Attorney Docket No. : LUKP:115US
Appl. No. 10/711,225
Amdt. dated June 22, 2005
Reply to Office Action of February 23, 2005

Amendments to the Drawings:

Amendments to the Drawings

Fig. 1

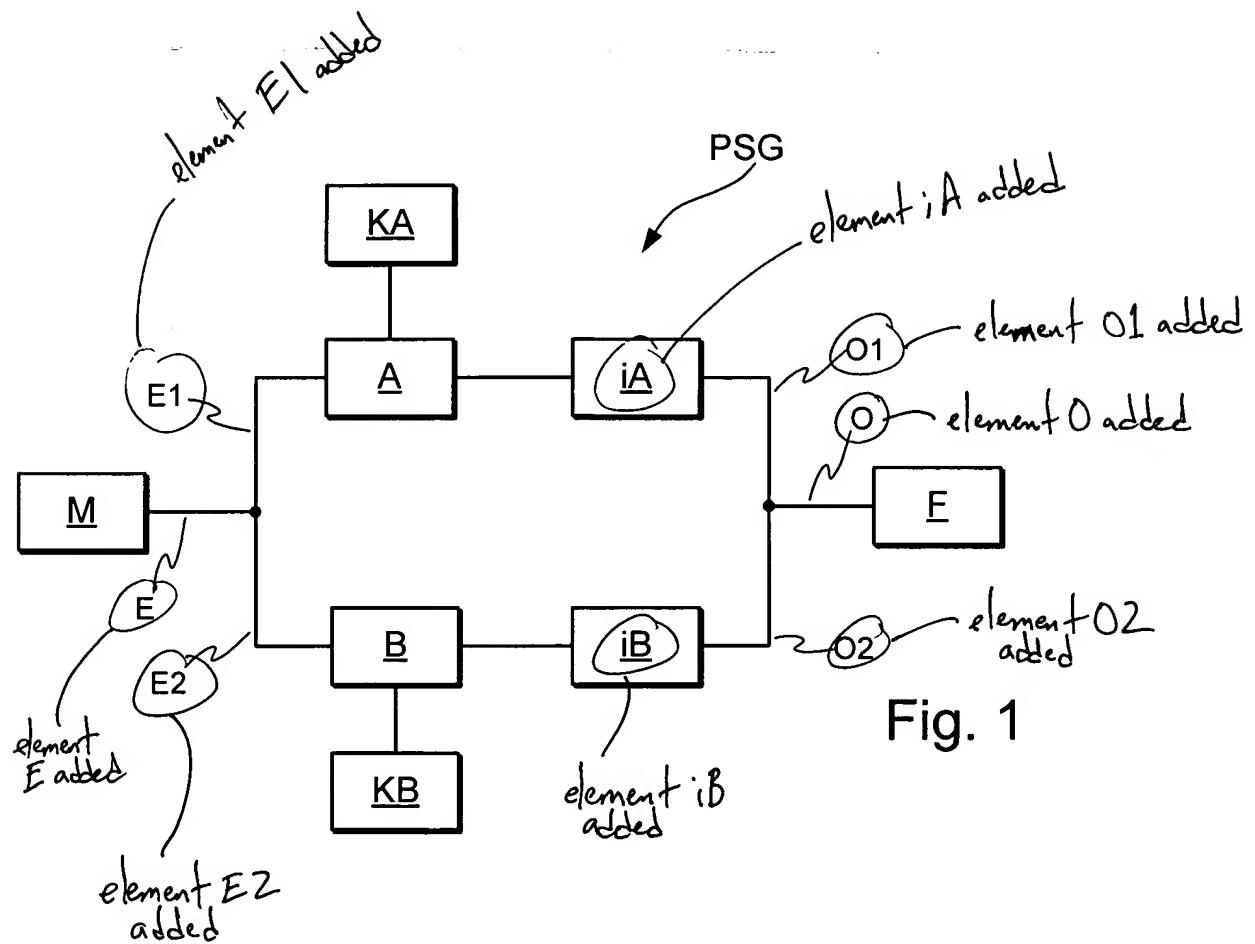
In amended Figure 1, previously omitted elements iA, iB, E, E1, E2, O, O1 and O2 have been added. Support for this revision is found in amended Paragraph [0024]. Pursuant to Examiner Lorence's request, Figure 2 was clarified by separating Strategy 1 and Strategy 2, thus clearly indicating the various methods of sensing point adaptation. Additionally, the previously omitted simultaneous method has been added to Figure 2. Therefore, Applicants respectfully submit that Figure 2 provides a diagrammatic representation of Claims 13-16. Support for replacement Figure 2 is found in Paragraph [0033] and new Paragraph [0033.1]. Again, pursuant
